September 30, 2024

**THE UNIVERSITY OF NEW ORLEANS
SCIENCE LAB UPGRADES PHASE III
H/S PROJECT NO. 23044**

**HOLLY & SMITH ARCHITECTS, APAC
2302 MAGAZINE STREET
NEW ORLEANS, LOUISIANA 70130**

This addendum forms a part of the Contract Documents and modifies the original specifications and drawings issued for bidding to the extent noted hereinafter.

SCIENCE BUILDING 1ST FLOOR
 GROSS AREA: 60,071.3 SQ. FT.
 USABLE AREA: 39,392.2 SQ. FT.
 UPDATED: 03022020 RJO VERIFIED: RJO

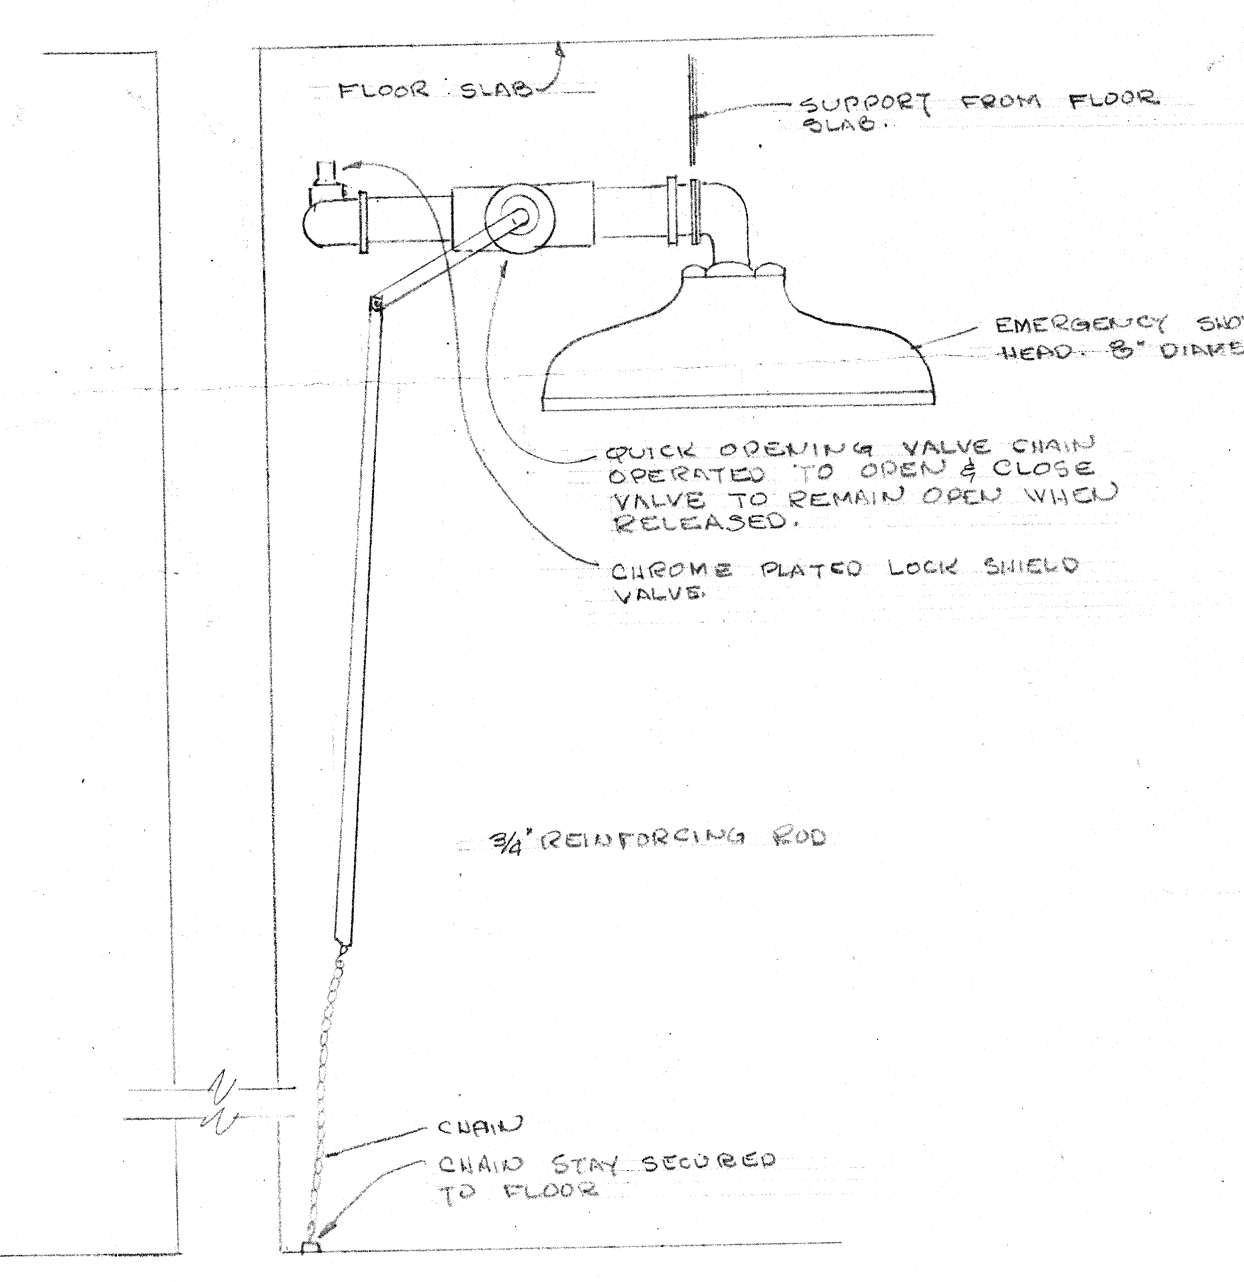
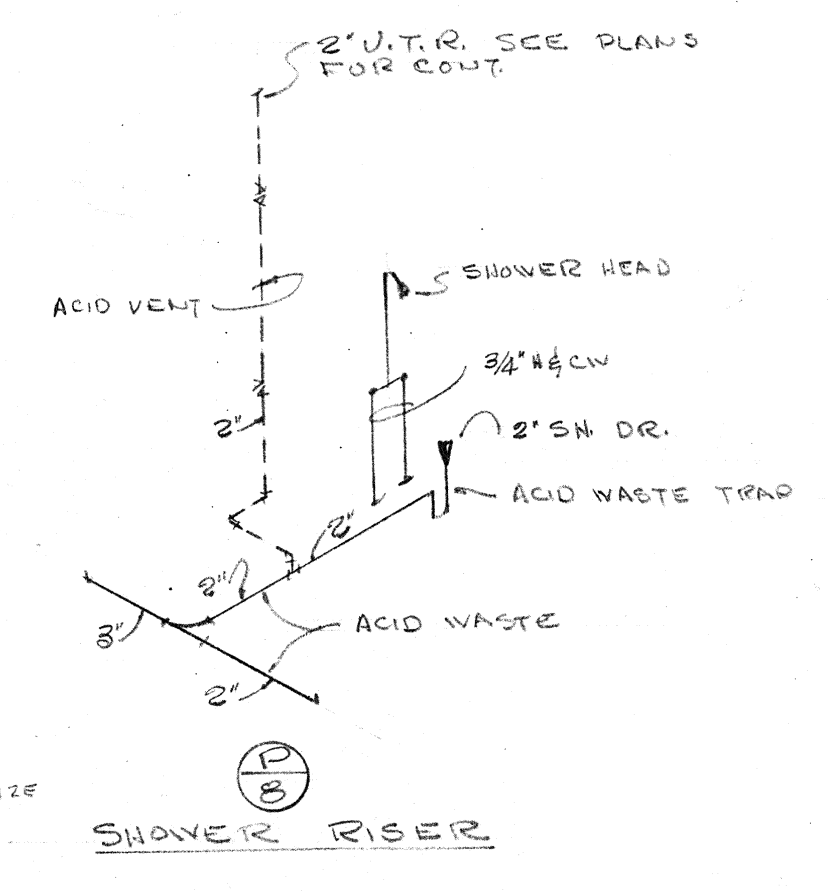
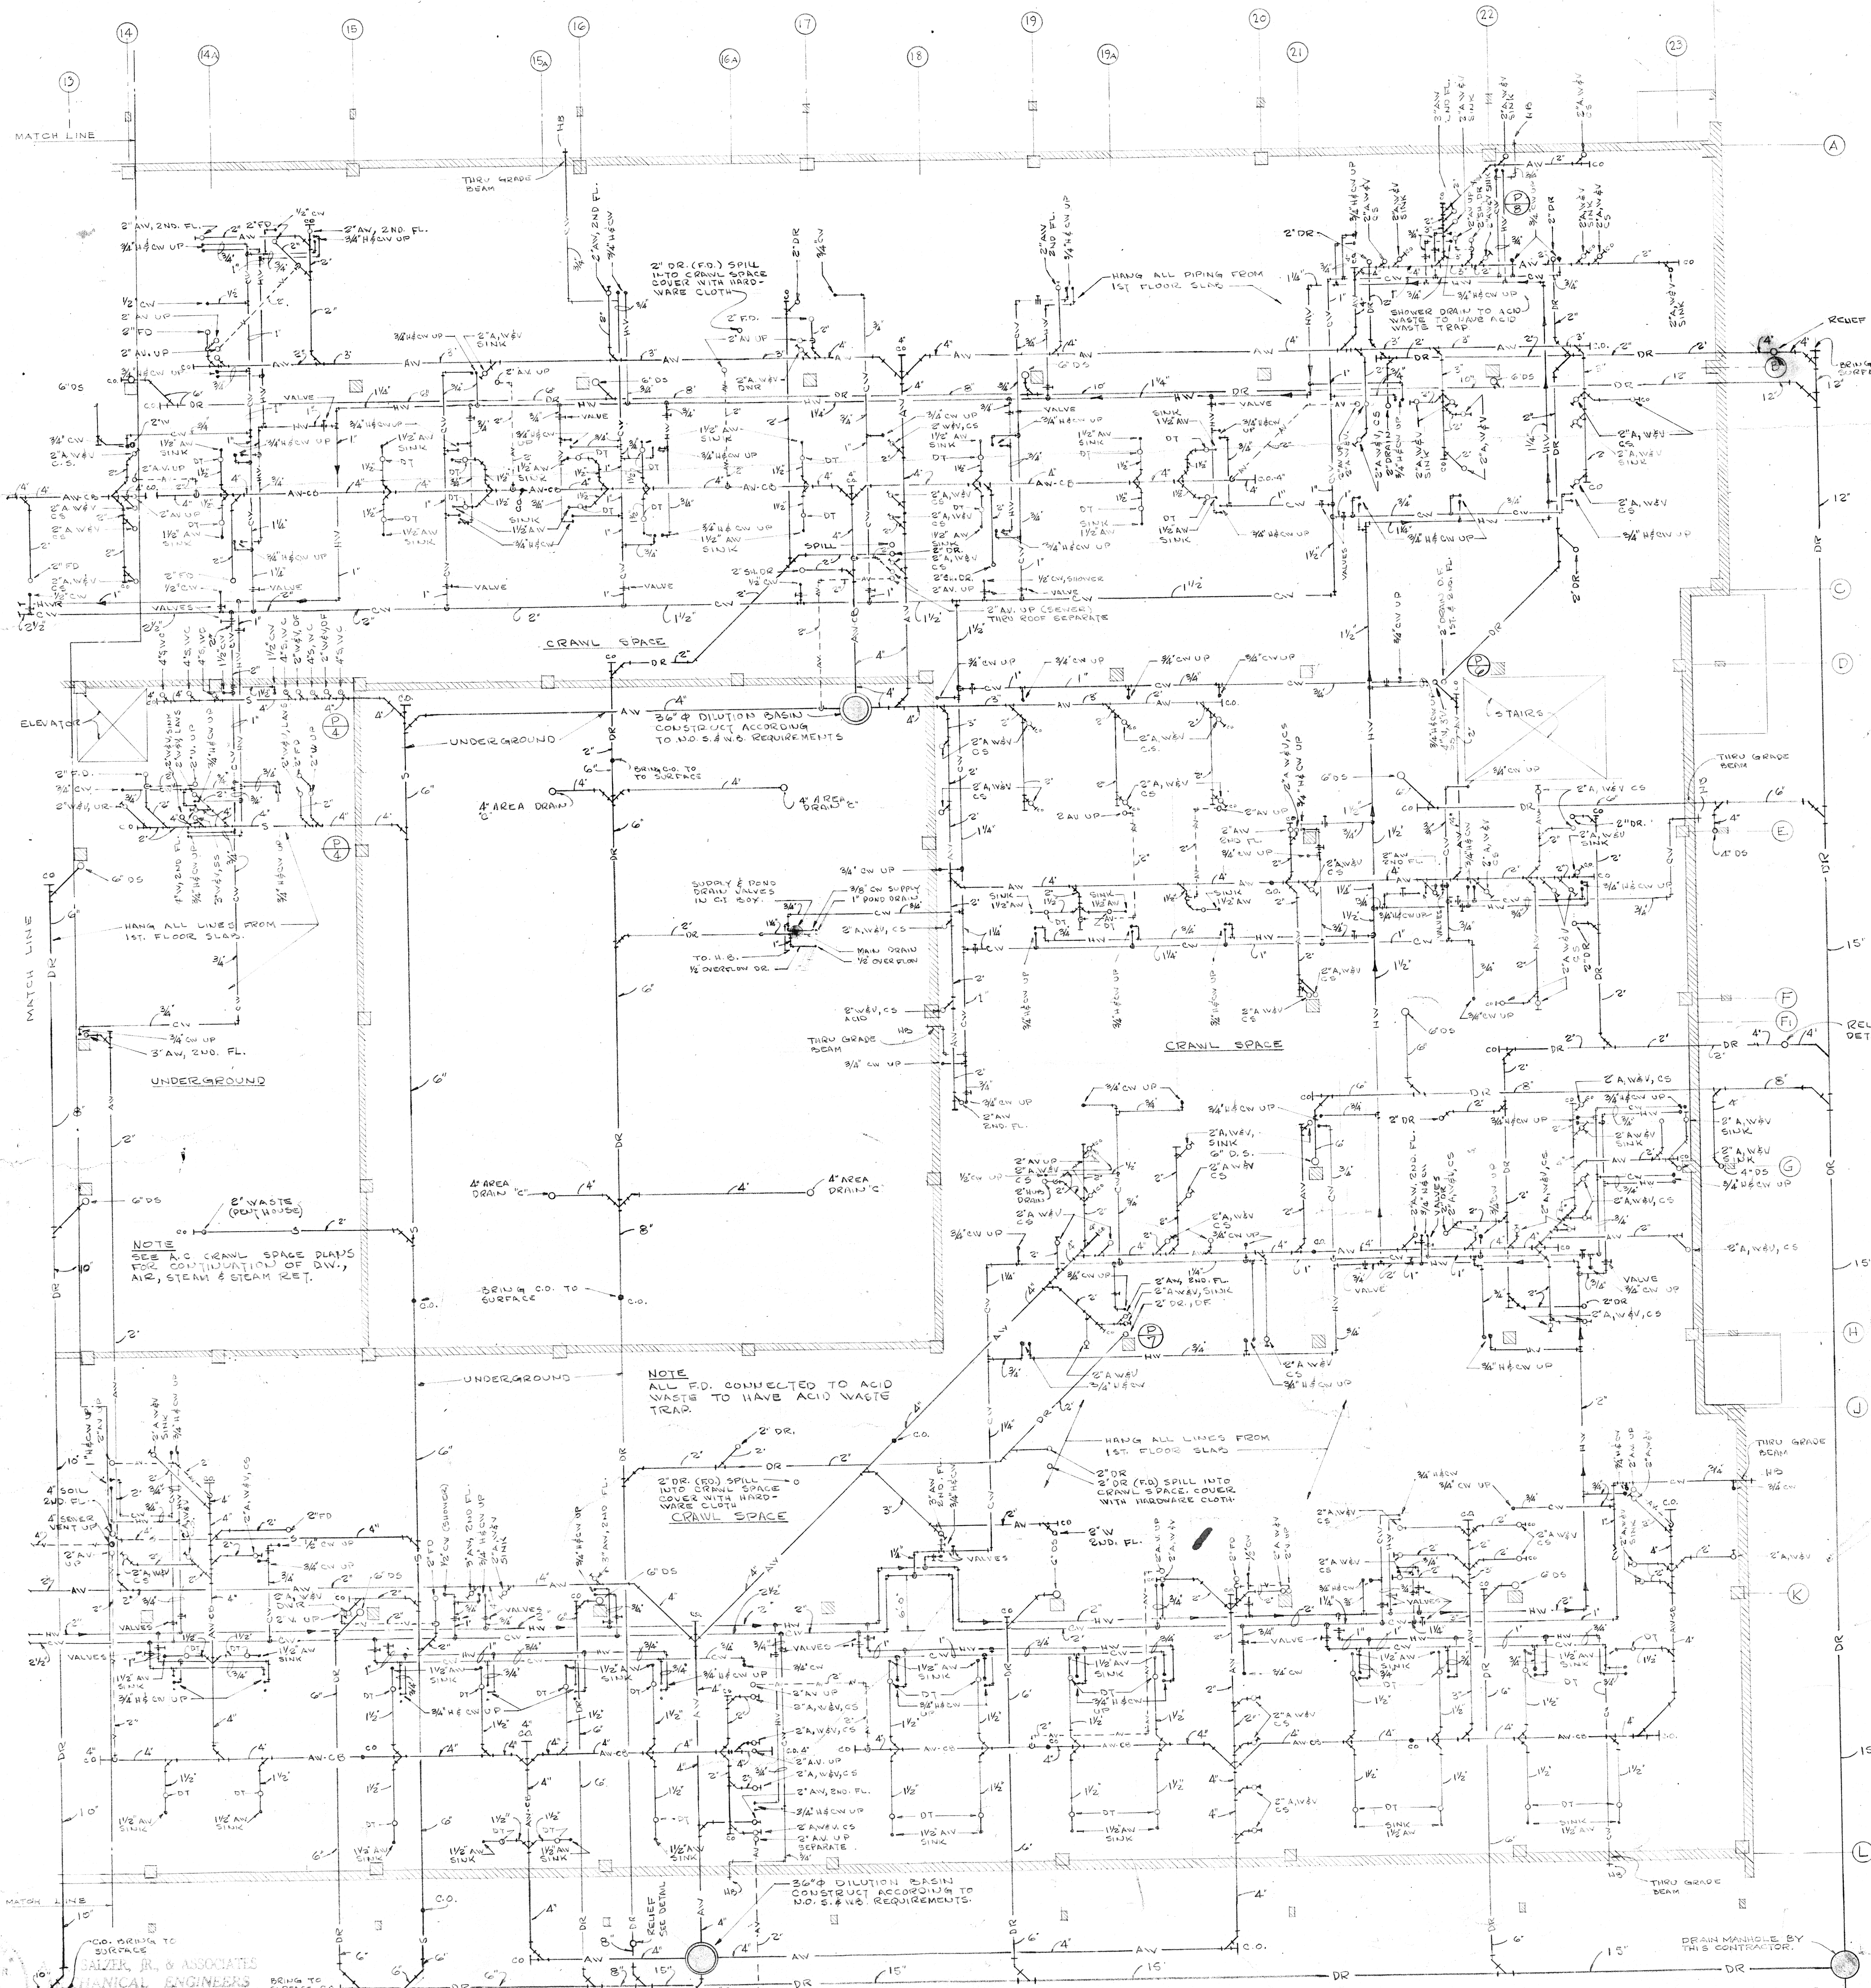
- 2.1 A copy of the original drawings identifying access to the crawl space, crawl space plumbing plan, an existing section of the crawl space, and images of the crawl space are included in this addendum for reference only. Contractor must verify existing conditions on site.
